1997 - 1998, 2000 Corvette: Service Bulletin: Electronic Steering Column Lock May Refuse to Operate - DIC Service Message Displayed

Number: 01-02-35-008

Subject: Electronic Steering Column Lock May Refuse to Operate - DIC Service Message Displayed (Update Column Lock Wiring, Install Revised Relay and/or Replace Electronic Column Lock)

Model Year: 1997-1998, 2000 Chevrolet Corvette Built Between the Following VIN Breakpoints:

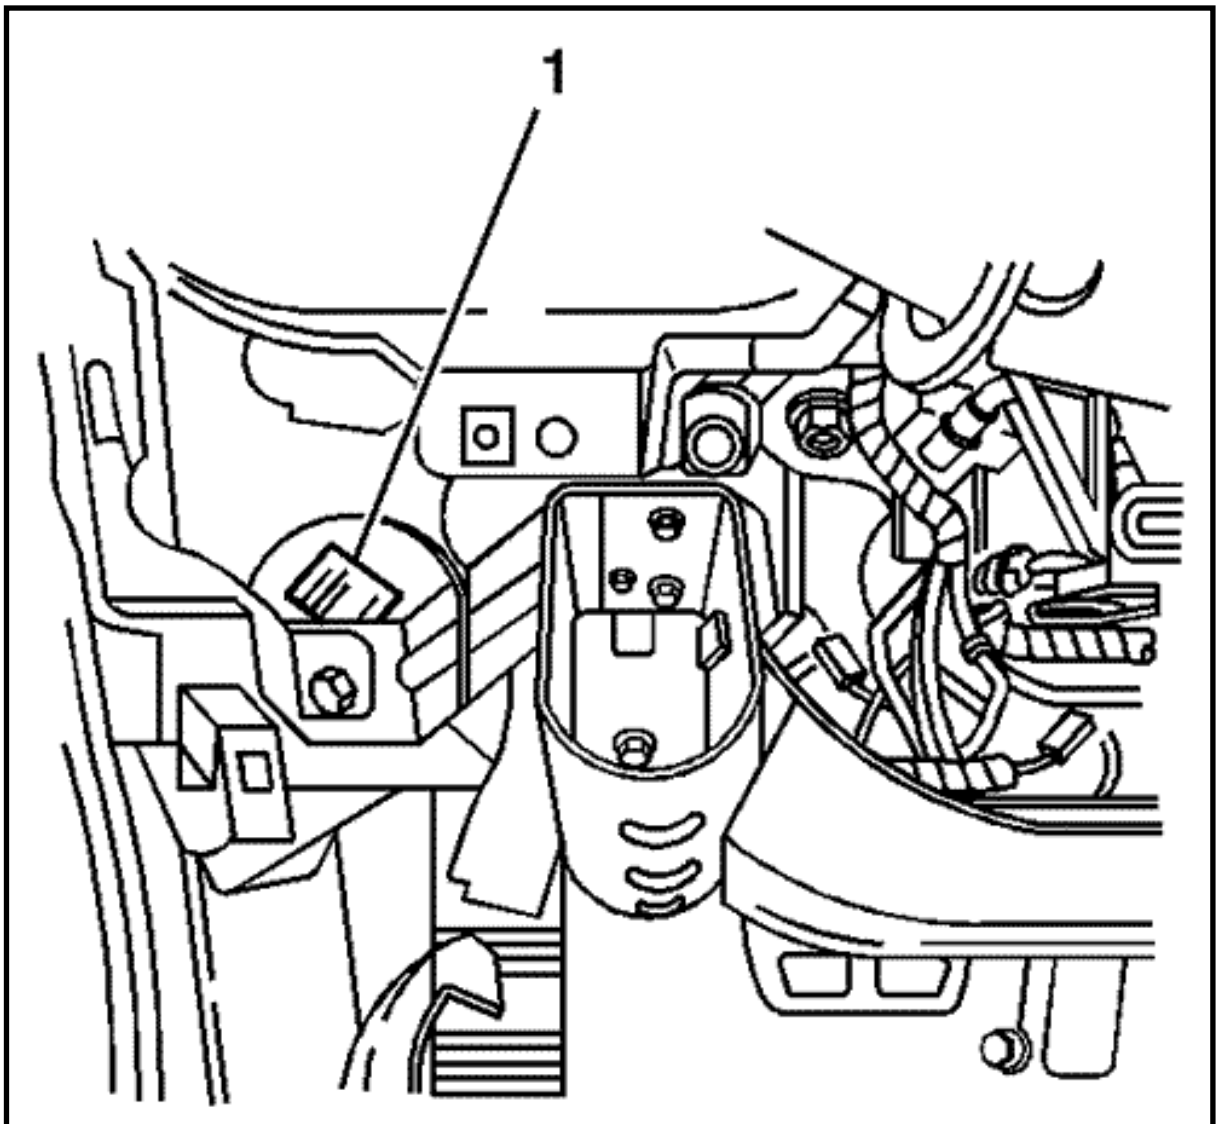
12. Remove and discard the Steering Column Lock/Cam Orientation plate

13. Install the included Cam Orientation Plate and secure with a new locking ring, using J 42137 and J 38364 as shown.
14. Install the SIR coil and secure with snap ring.
15. Disconnect the connector from the ECL (located on the right lower side of the steering column) to the I/P main harness.

FIGURE 1997 and 1998 (early) Manual (U.S. & Canada and All Export (Manual & Auto)(c)

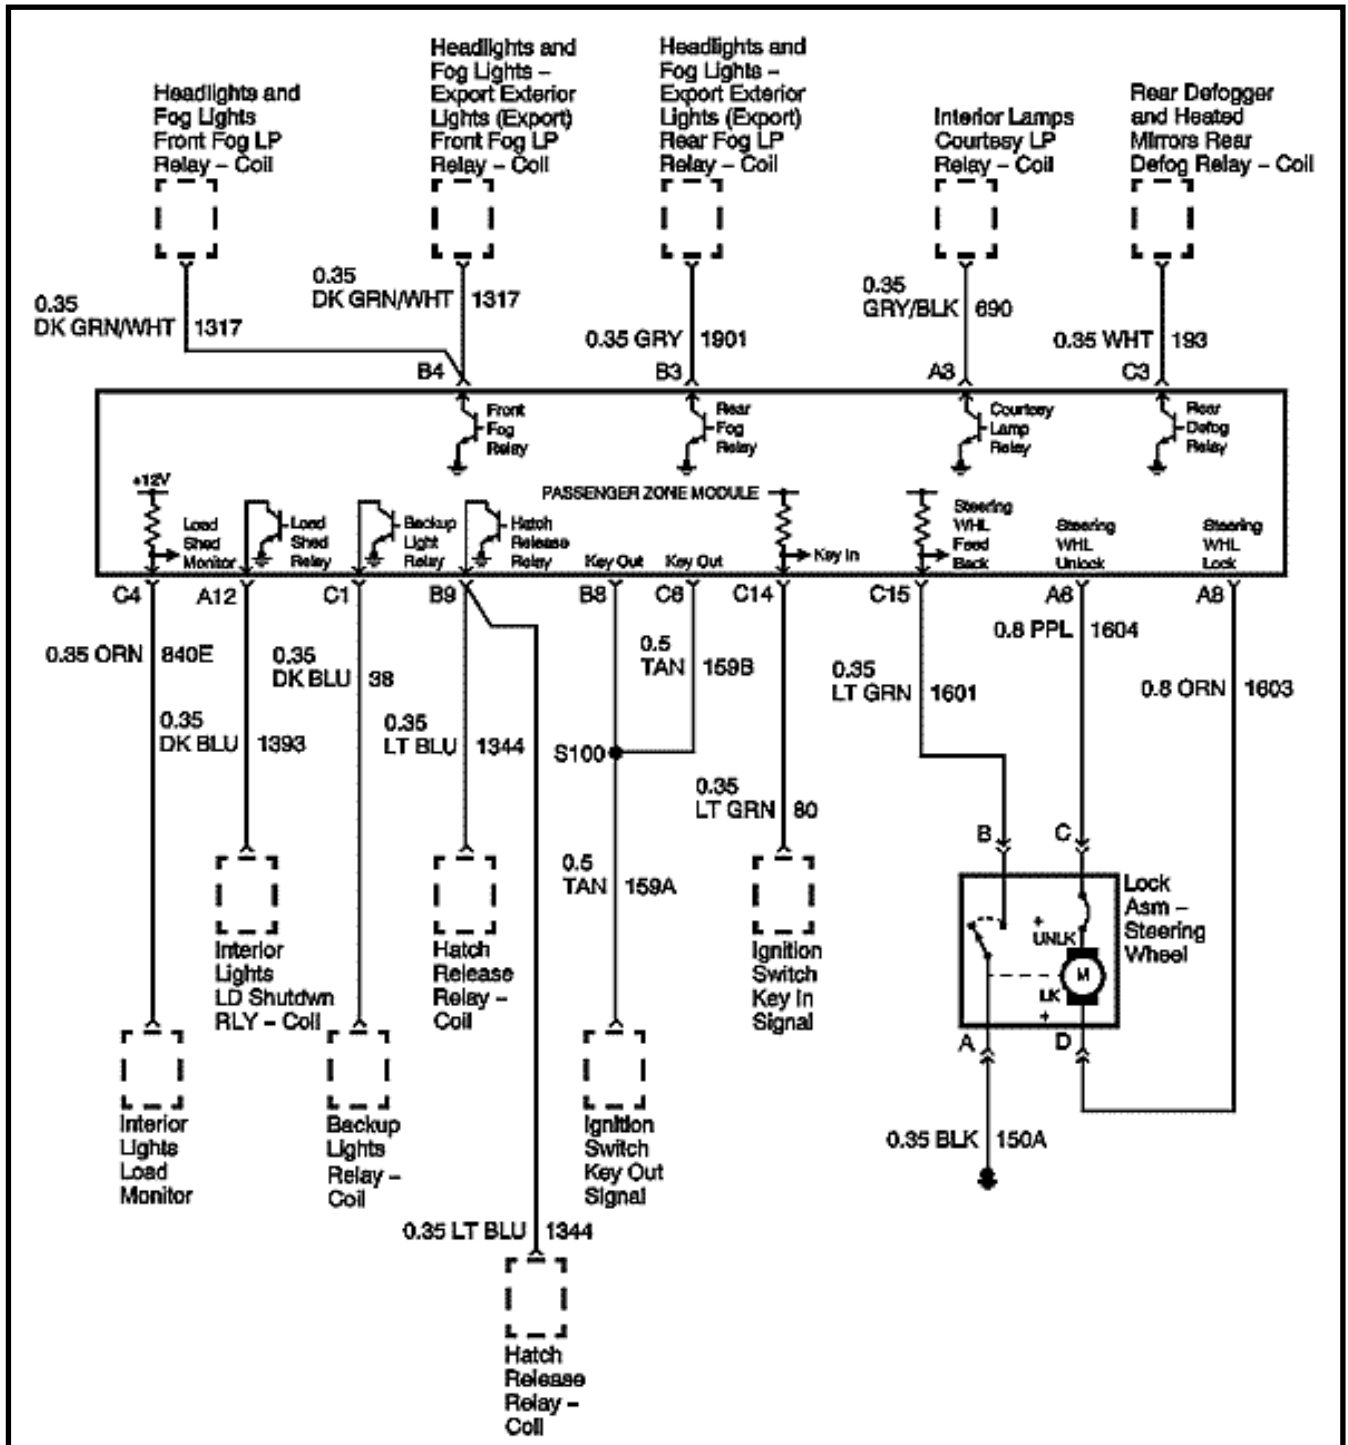
- **When removing the driver's side knee bolster trim panel as described below, care must be taken not to damage the console trim plate as the knee bolster trim panel tucks in behind the console trim plate.**
- **Revised schematics are included to aid and/or verify the proper installation of the service kit.**
